MEMORANDUM

Date: September 8, 2025
To: Planning and Zoning Members
City Council Members
From: Dinh V. Ho, P.E.
RE: 189 Ac Coogan Tract Plan of Development
Staff's Summary and Recommendations
CC: Mayor Wil Kennedy, Natasha Brooks Anderson, Kayleen Rosser

**Coogan Tract
Planned Unit Development
District**

Exhibit E – Street and Circulation System Exhibit

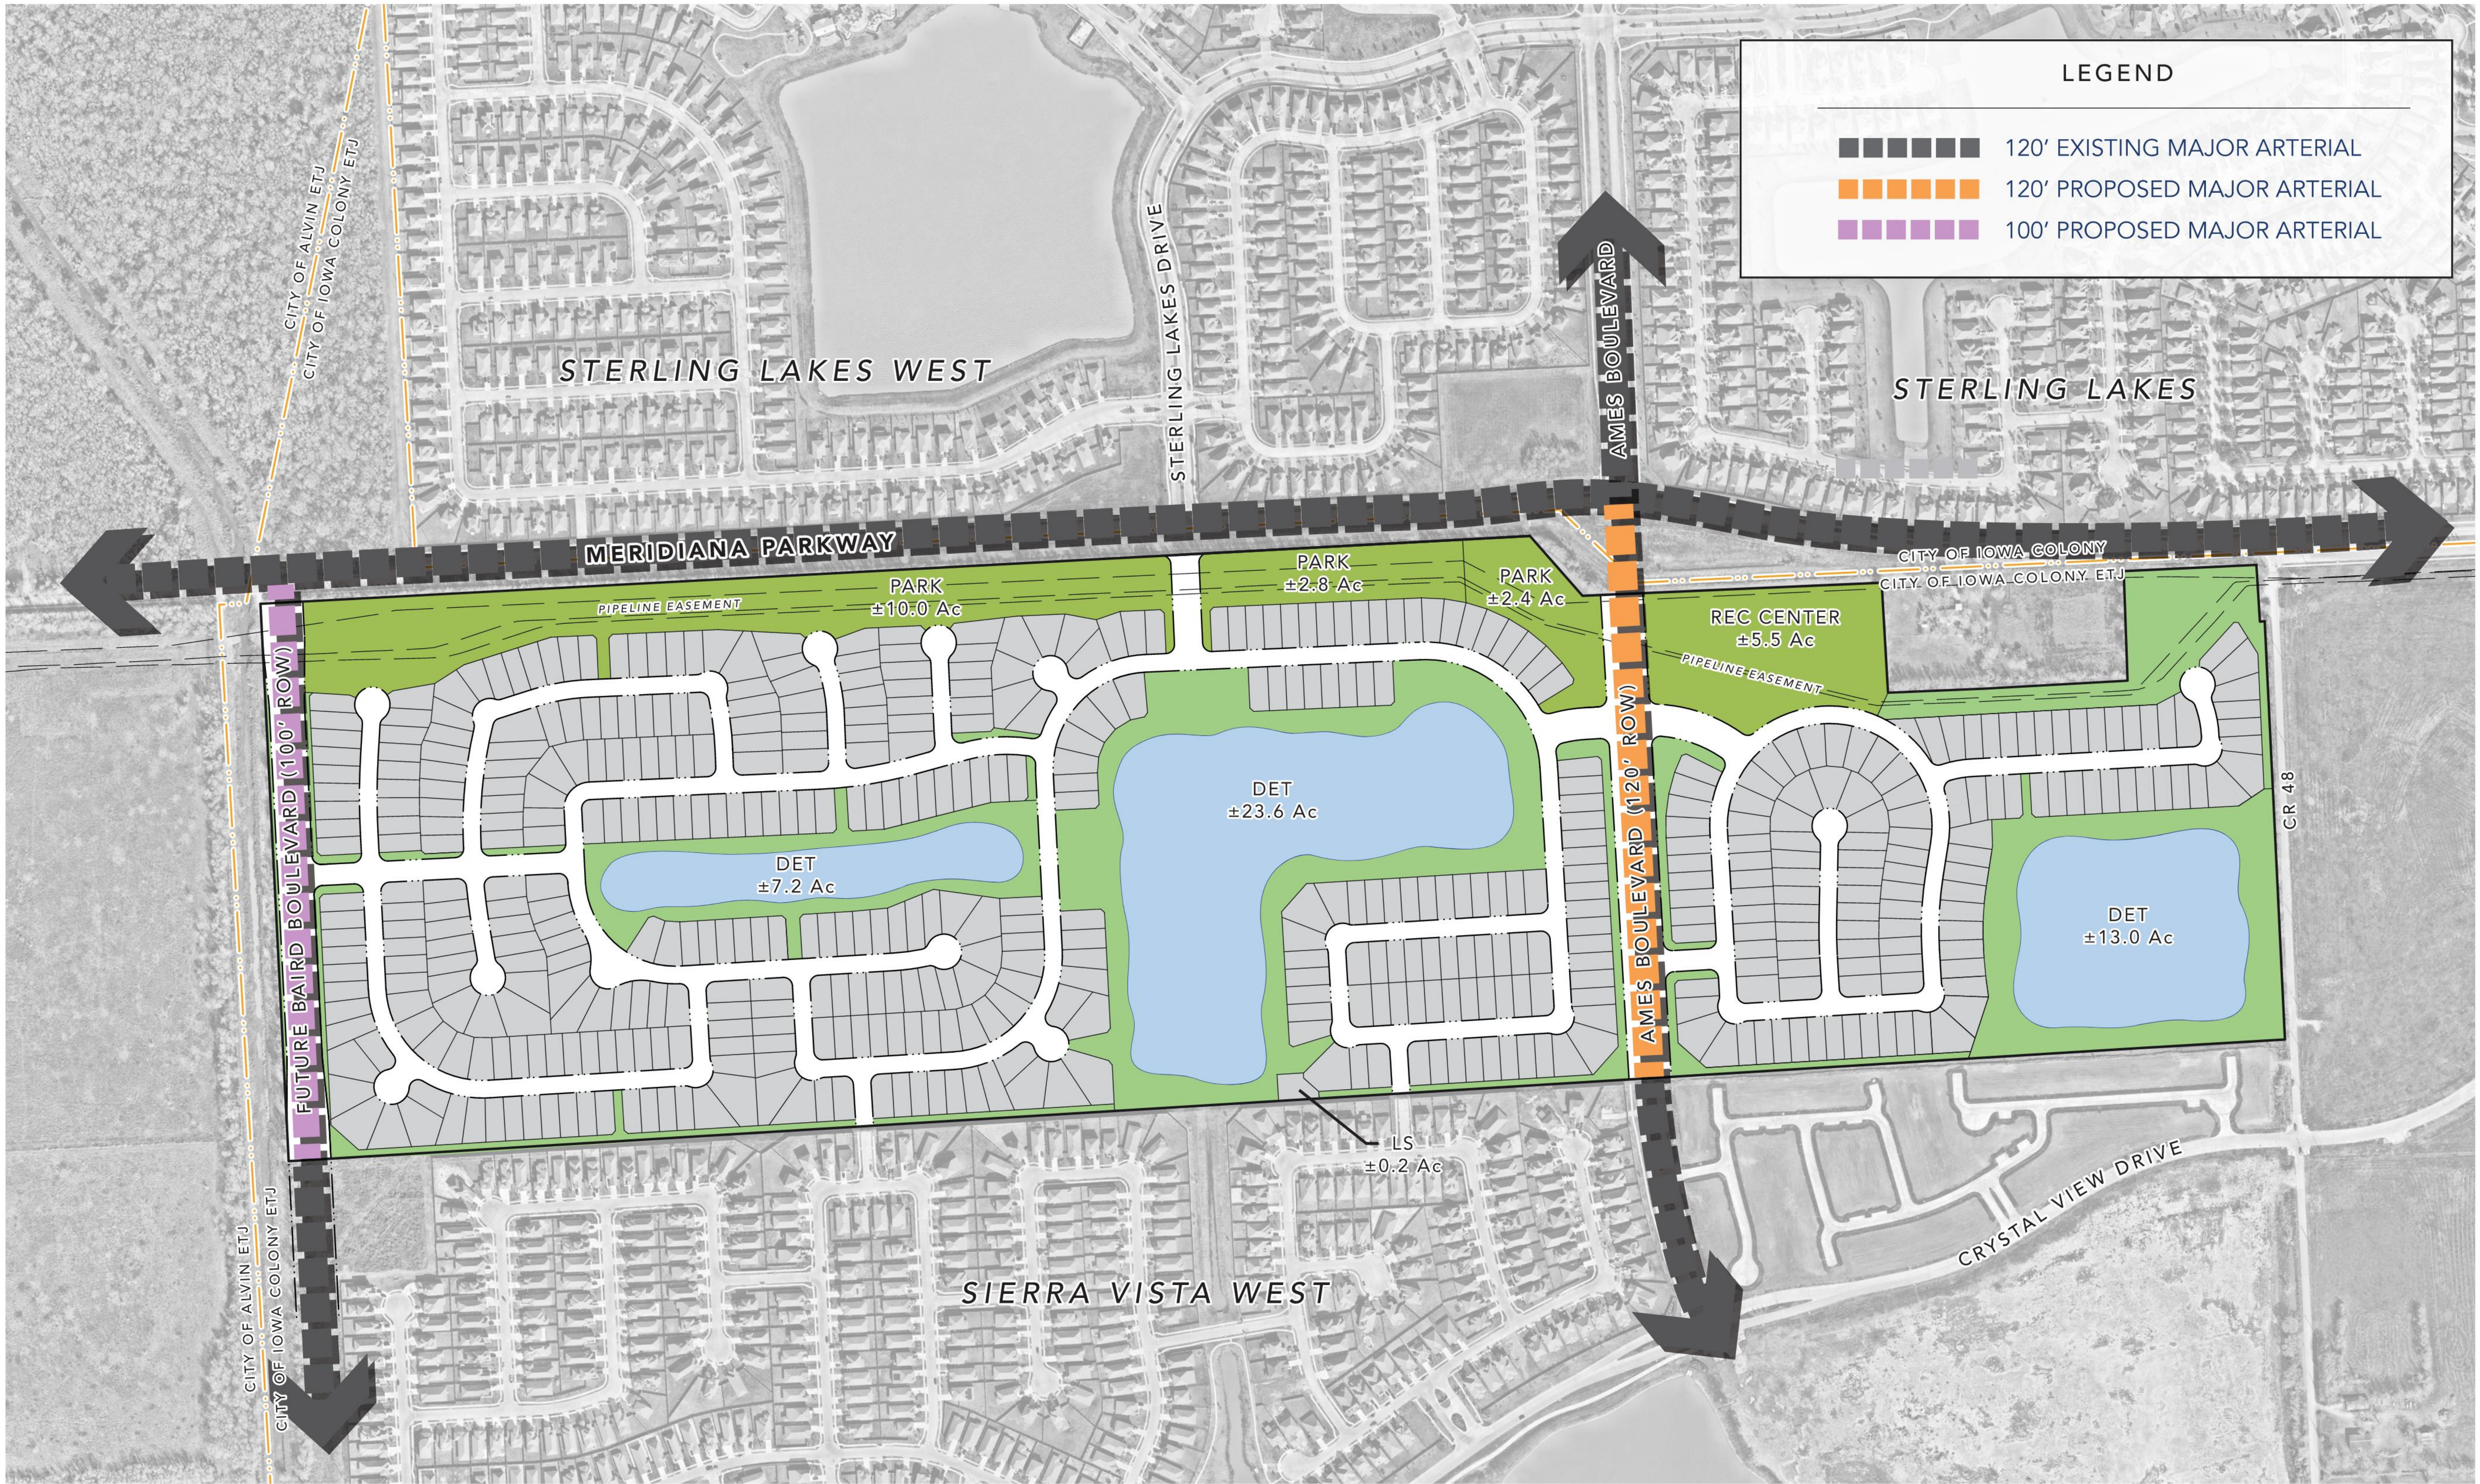
- 1) *Roadway Improvements: All exhibits*
 - a. *Remove all reference to Baird Boulevard as future. Staff recommend Baird Blvd. to be required to be constructed to be half width (2-lanes) south of the Meridiana.*

- b. *Proposed ROW at the intersection of Baird/Meridiana Parkway shall be 120', but transition to 100' south.*
 - c. *Improvements along Meridiana Parkway and Ames Blvd. as to be constructed as part of the development.*
